BLUE WING ROAD TO IH 37 SEWER PROJECT
Solicitation Number: CO-00316
Job No.: 19-4517

ADDENDUM 1
December 12, 2019

REV. NO.	DATE	DESCRIPTION	BY
1	12/11/19	ADDENDUM No.1- REVISED NOTE	
		BLUEWING ROAD TO IH-37 SEWER PROJECT 60-INCH SAN. SEW. CIPP PLAN STA. 1+00 TO STA. 9+00	
DATE: NOVEMBER, 2019	SAWS PROJECT NO.	SHEET NO.	
DESIGN: MR	19-4517	C1	
DRAWN: IL	CDS PROJECT NO.		
CHECKED: KRR	117270.04

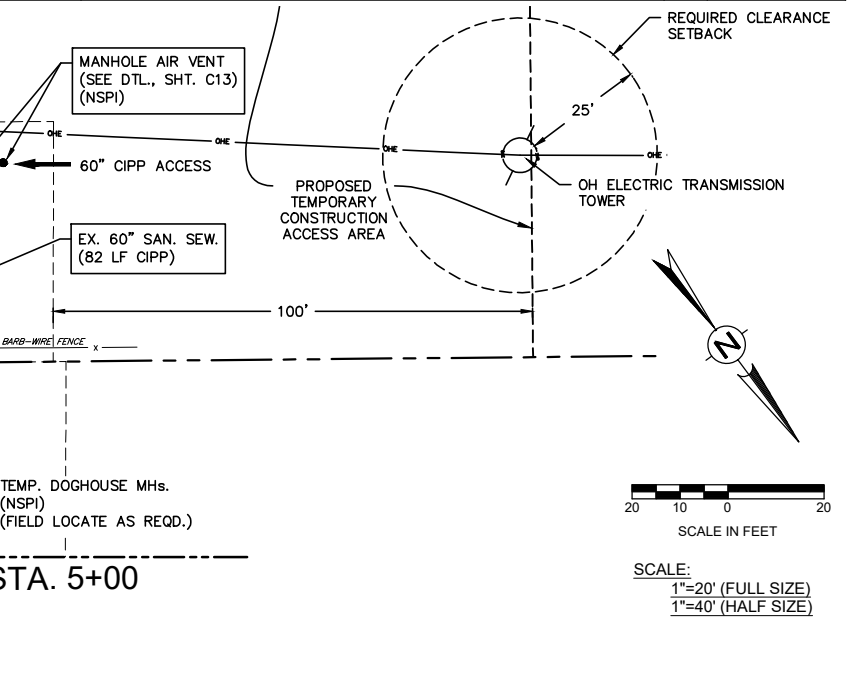
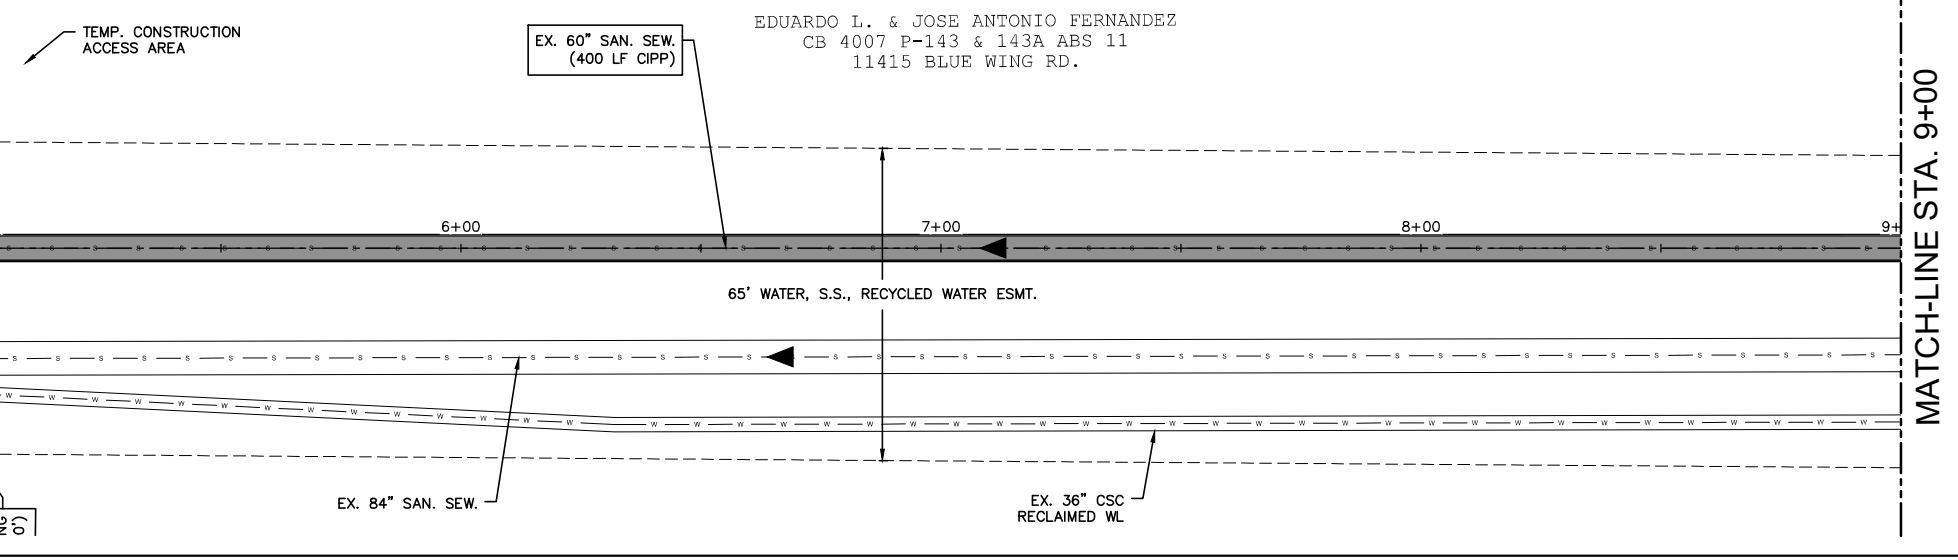
- 1. Plan Sheet C1:** Remove and replace Plan Sheet C1 with the revised Plan Sheet C1 attached to this Addendum. Plan Sheet C1 has been revised to include a call out note requiring the Contractor to field locate manholes as required so there is a minimum separation of 10 feet from the outside of the manholes to the existing 16-inch DI water line on Blue Wing Road.
- 2. Plan Sheet C4:** Remove and replace Plan Sheet C4 with the revised Plan Sheet C4 attached to this Addendum. Plan Sheet C4 has been revised to remove the “NSPI” designation from the 24” PVC cross-over pipe.
- 3. Plan Sheet C10:** Remove and replace Plan Sheet C10 with the revised Plan Sheet C10 attached to this Addendum. Plan Sheet C10 has been revised to clarify the size of manhole required on the existing 84” sewer line and to correct Item No. 862.3 in the Item No. column of the Estimated Quantities table.

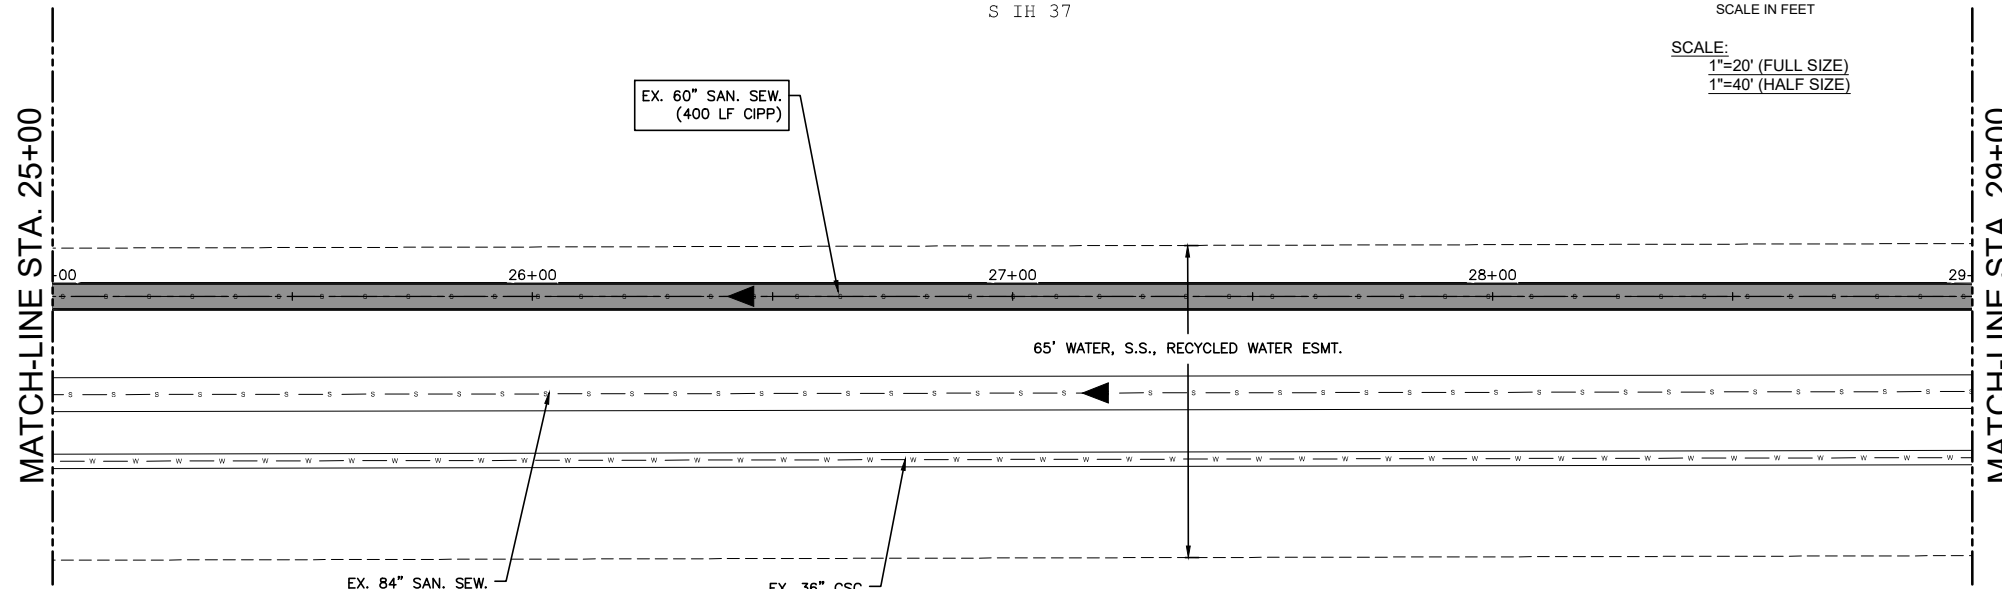
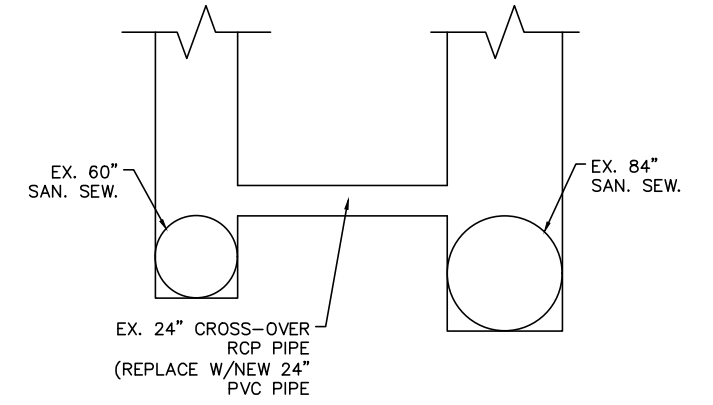
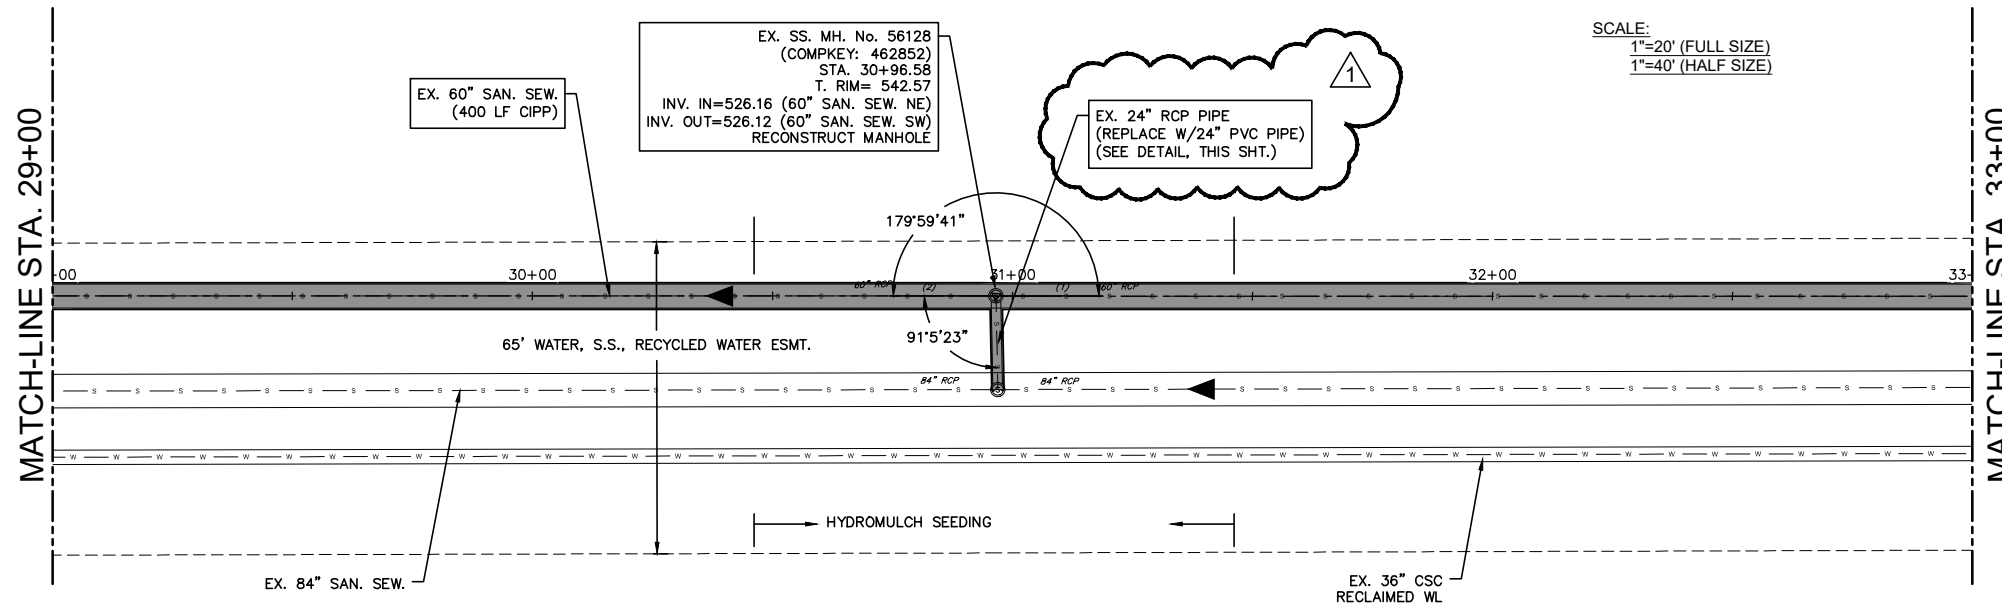
Response: Contractor's may obtain related as-builts (DJ-4310) and block maps from SAWS Counter Services Division.
- 3. Question:** Plan sheet C4 of the plans, it appears that a pay Item is provided for replacing the 24" cross-over pipe. However, it is designated on the sheet as "NSPI". Please Clarify.

Response: The 24" PVC cross-over pipe will be paid for by the LF. Plan Sheet C4 has been revised accordingly and included in this Addendum. Refer to Modifications to Plans for Construction for this Addendum.

SHEET NO.
C10

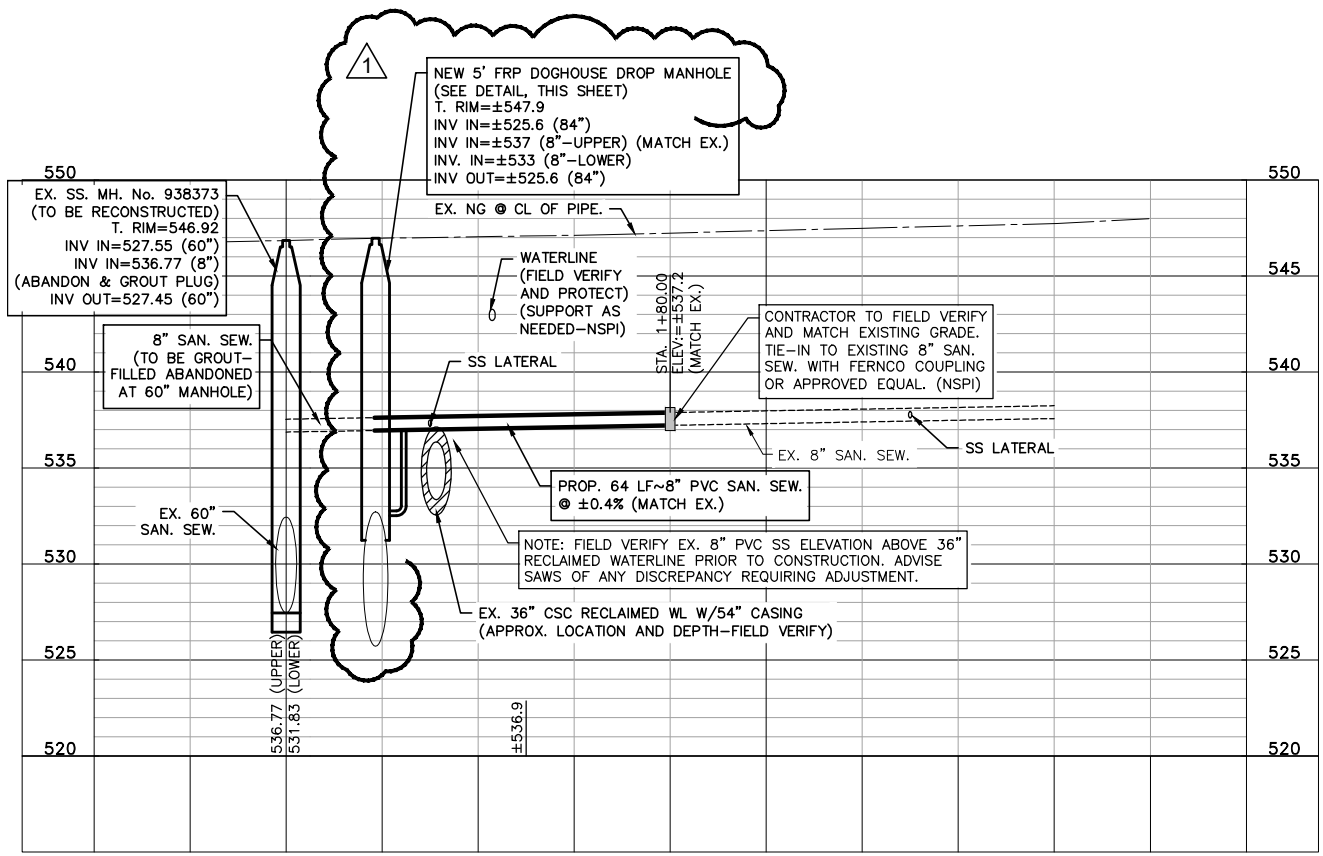
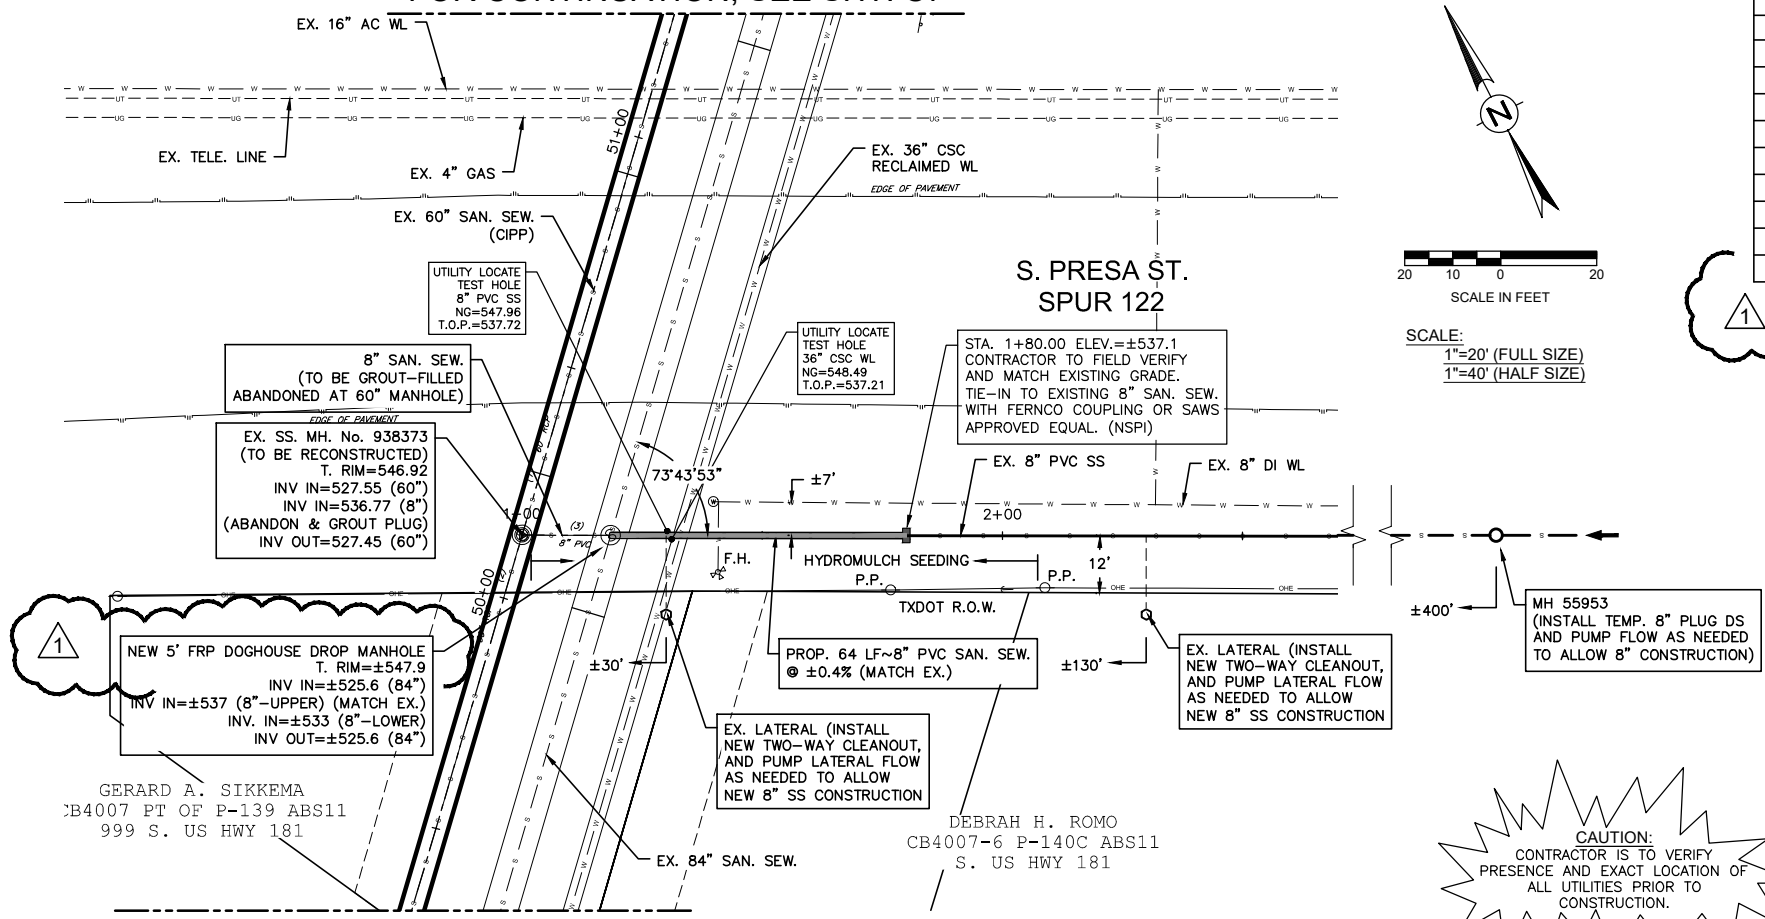
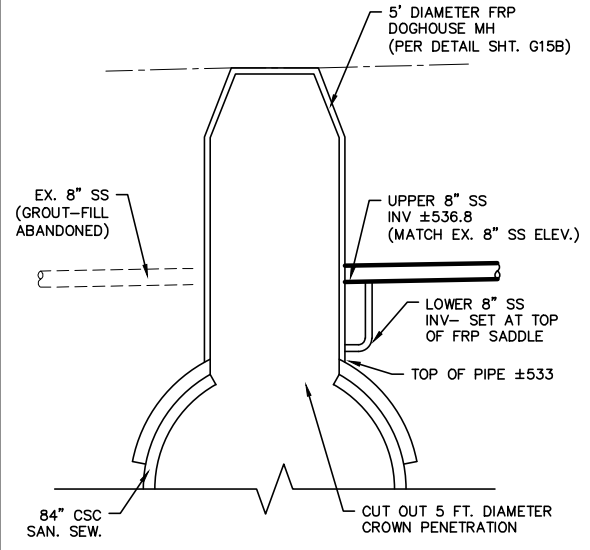
- 5. Question:** Plan sheet C10. "Estimated Quantities" are calling for a 5' diameter manhole, however profile notes are calling for an 84" diameter drop manhole. Please clarify what size manhole is to be installed and provide the appropriate pay item including extra depth, if not 5' diameter.

Response: The planned manhole is 5' diameter. Plan Sheet C10 has been revised accordingly and included in this Addendum. Refer to Modifications to Plans for Construction for this Addendum.
